IFC Design Analysis

WWYK190068 Repair Fire Suppression System, Maint Hangar B2280

Revision 1

Project Number: WWYK190068
Work Order: 20435 - Amend

SHEET TITLE
PROJECT DRAWING INDEX AND VICINITY MAP

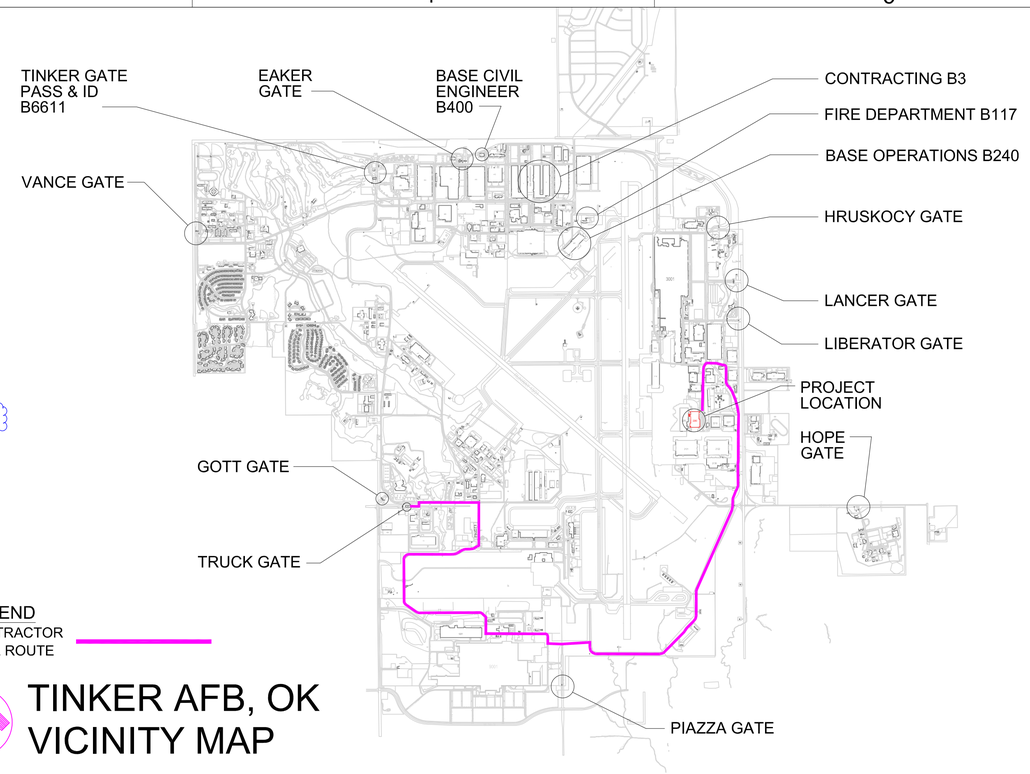
COMMENT FOR MODEL MANAGER/PM
THIS IS A DUST OFF PROJECT SO CONFIRM IF SHEET ORDER NEEDS TO/SHOULD BE UPDATED TO THE TYPICAL USACE SHEET ORDER REQUIREMENTS

1 G-002 GENERAL PHASING PLAN
SCALE: N.T.S.

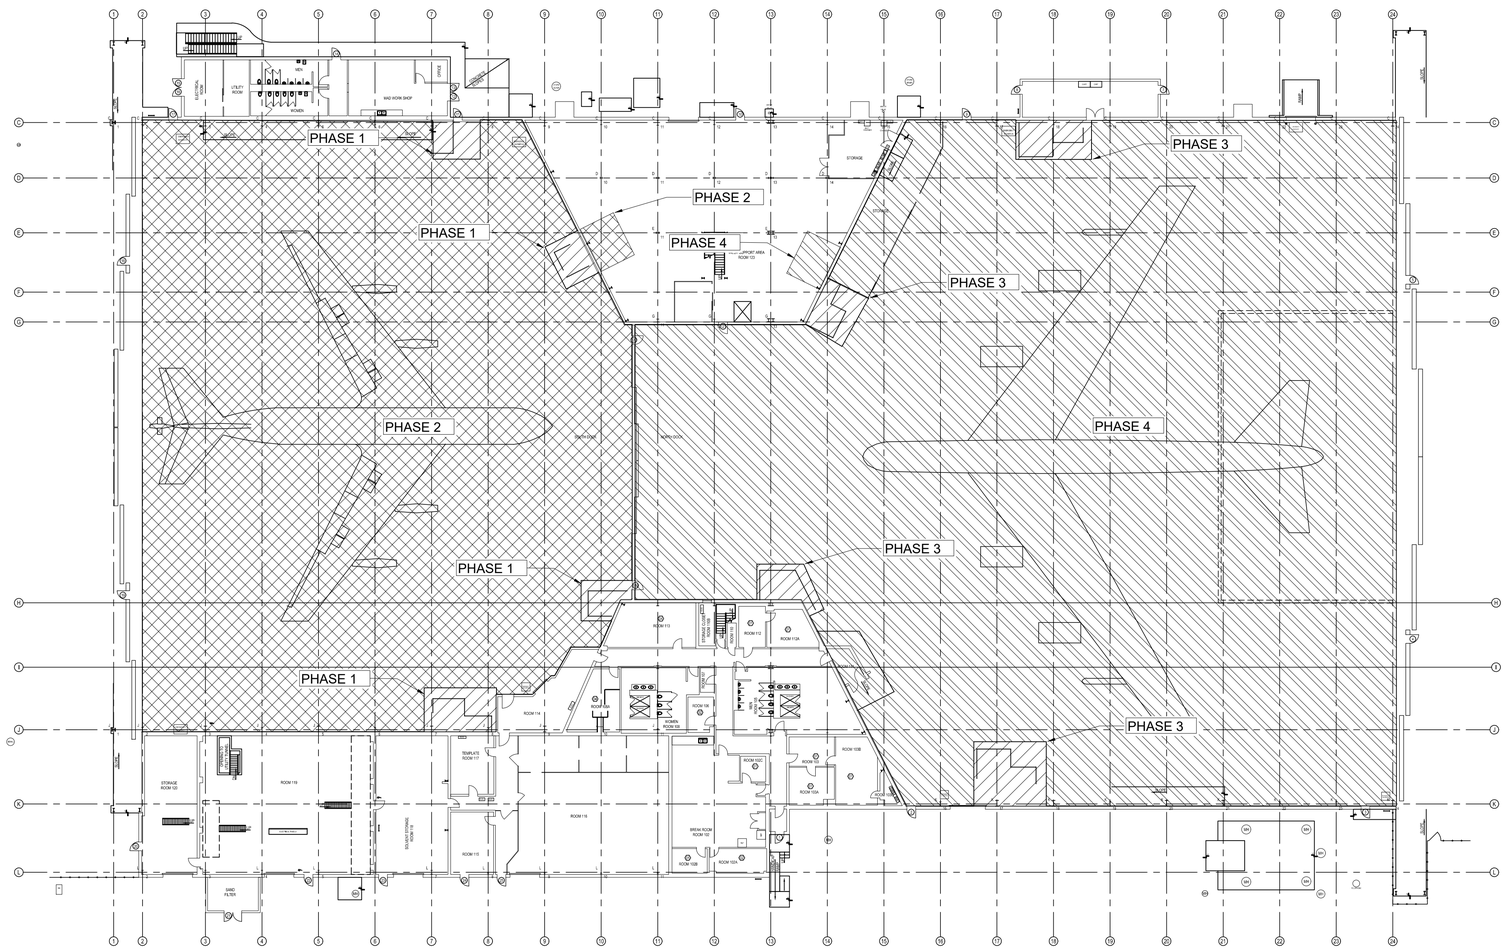
Has the phasing plan been updated to reflect the demolition items that will fall under a separate AFCEC contract?

Should we have a legend for the phase hashing?

Phasing Sheet G-002 states concentrate tanks need to removed under a specific phase. Is it the plan for the separate AFCEC contract to happen at the same time to align with this project or do we need to remove these items from the phasing plan sheets as well?

Update

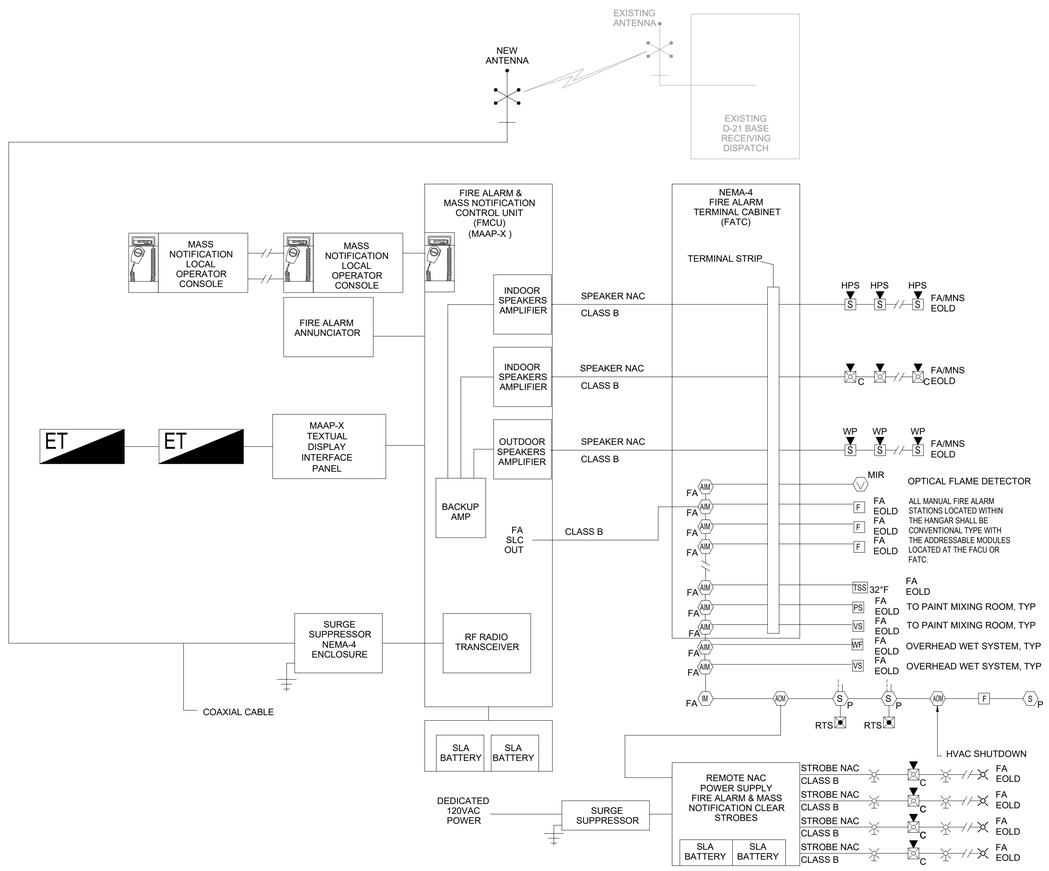
Title?

1 FX101 FIRE SUPPRESSION FIRST FLOOR PLAN - AREA A - NEW WORK

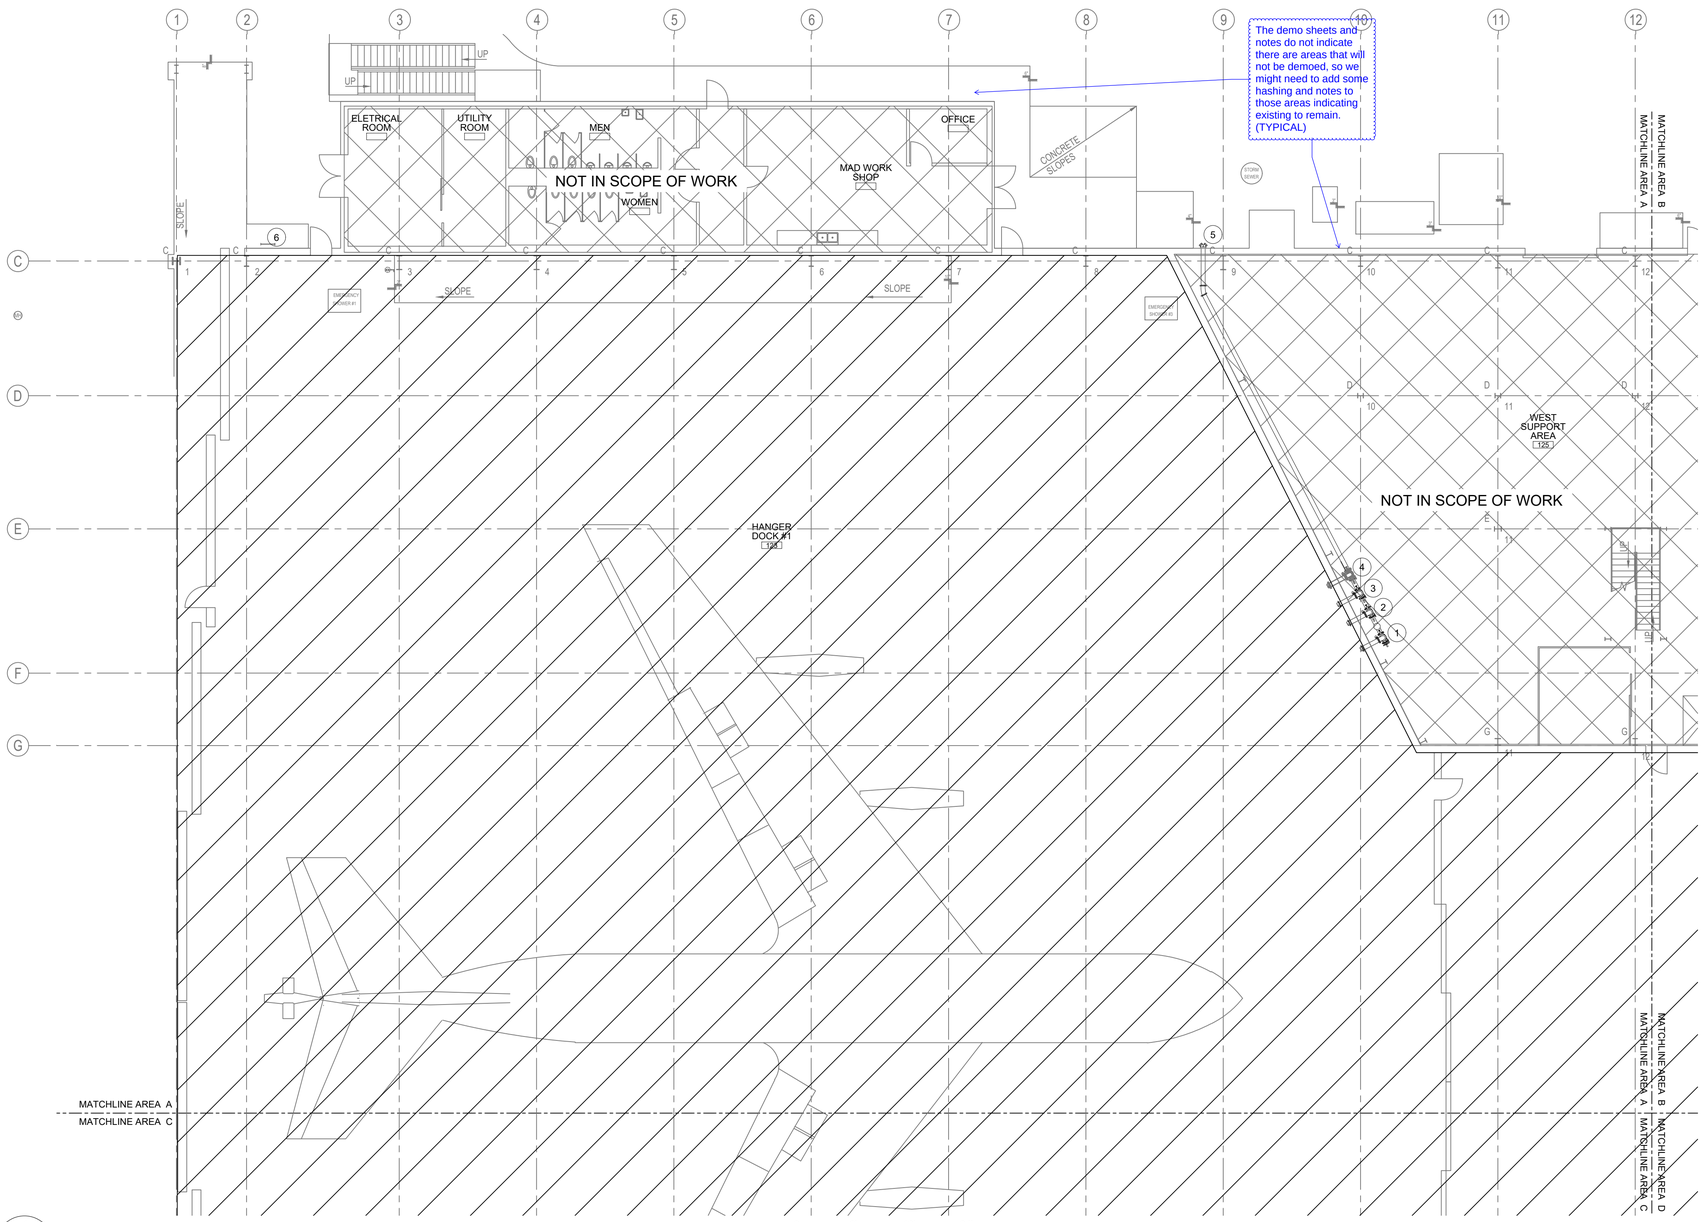
The demo sheets and notes do not indicate there are areas that will not be demoed, so we might need to add some hashing and notes to those areas indicating existing to remain. (TYPICAL)

1 FX103 FIRE SUPPRESSION FIRST FLOOR PLAN - AREA C - NEW WORK

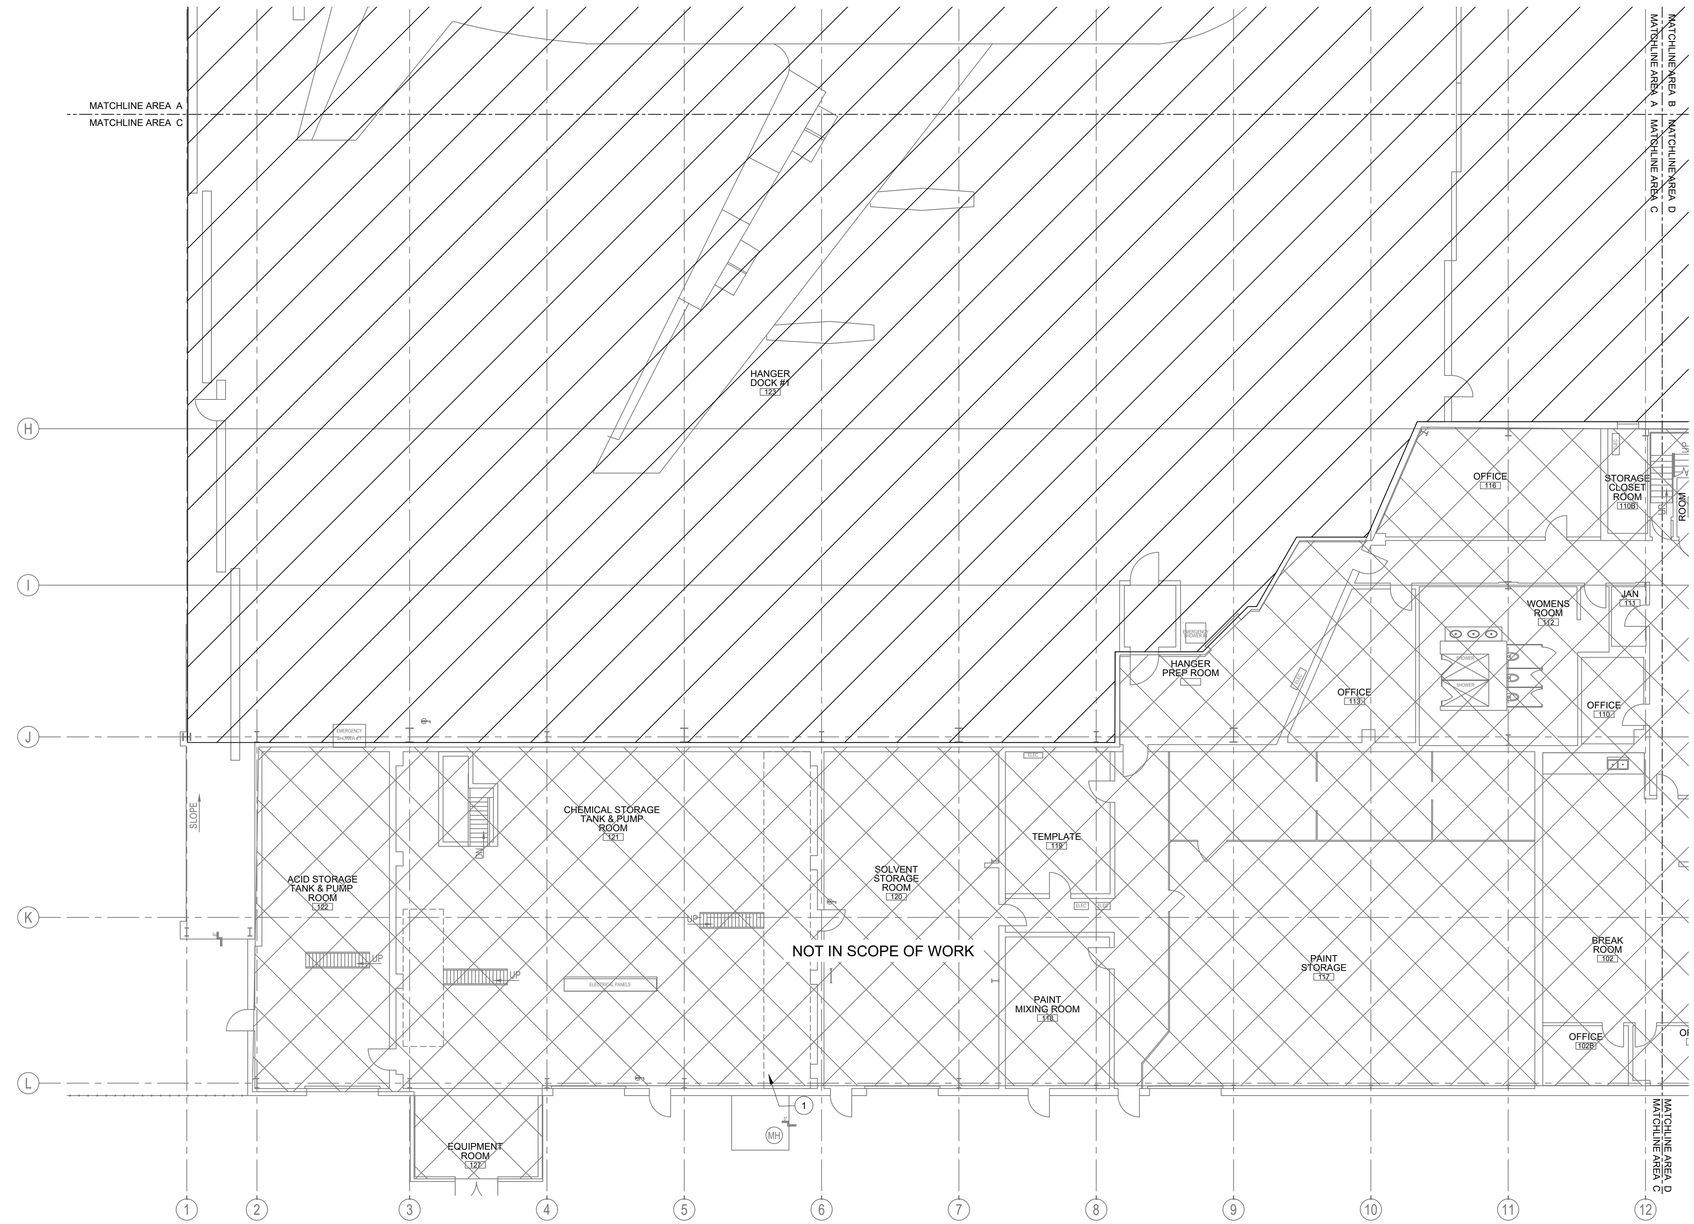
No sheets for Mezz and Floors 2 & 3, even if to sow it not in scope of work?

2 A-401 ARCHITECTURAL ENLARGED FLOOR PLAN - NEW WORK

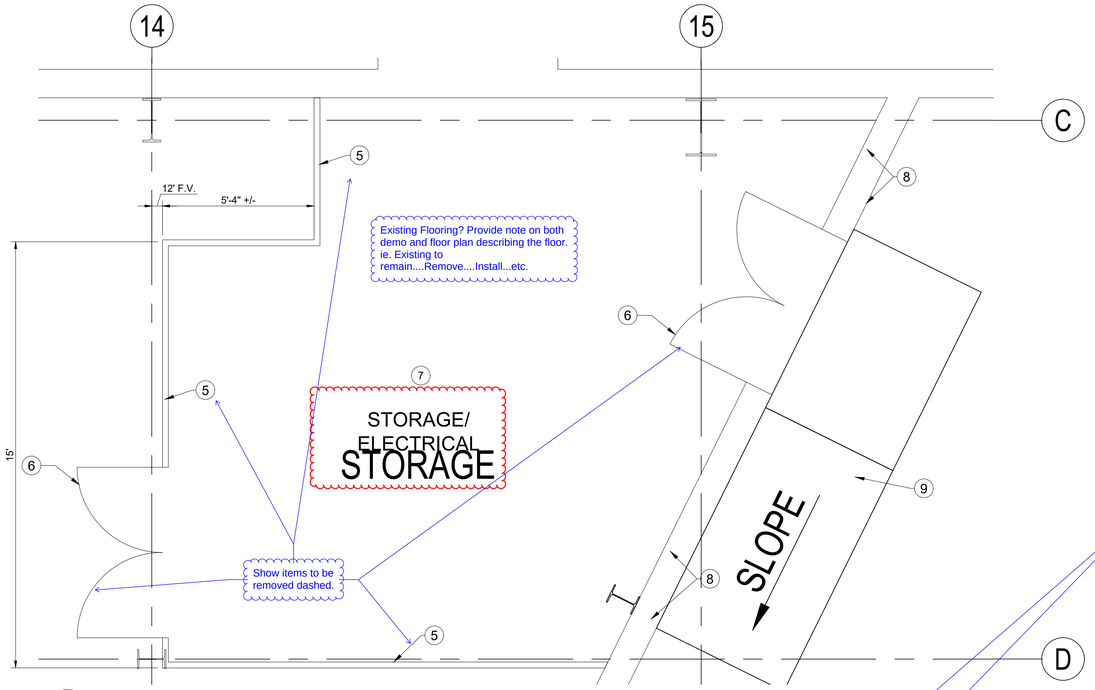
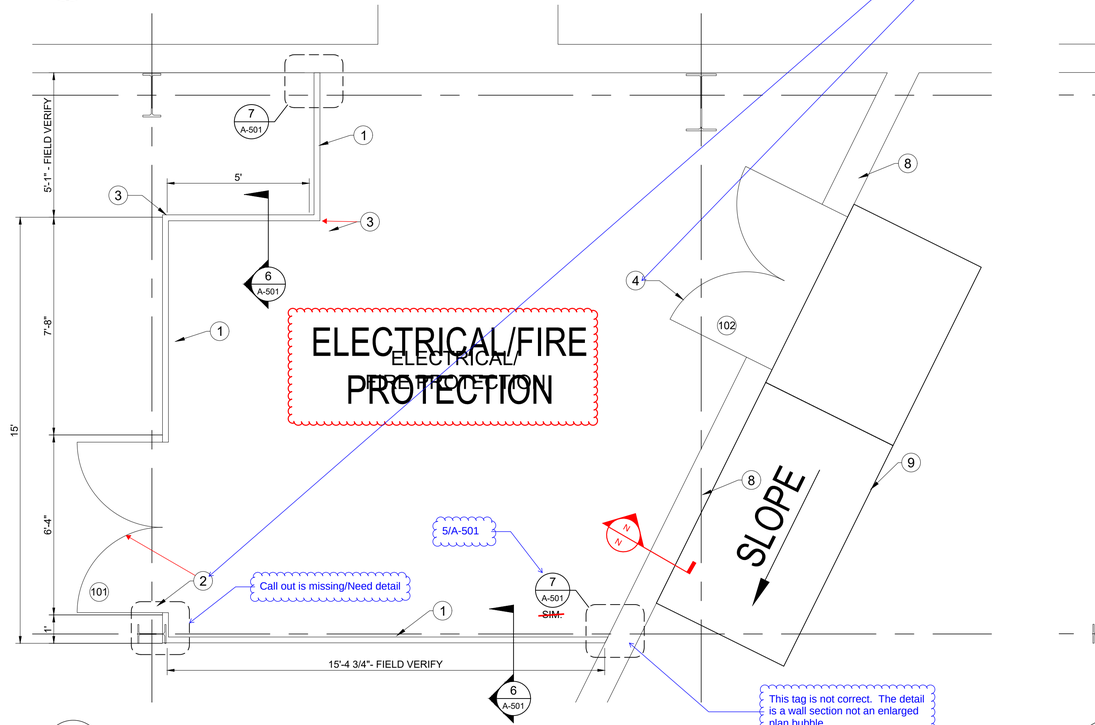
Verify 12" Coordinate with structural

Key note 1 on sheet A-401 indicates fiber cement board - please clarify
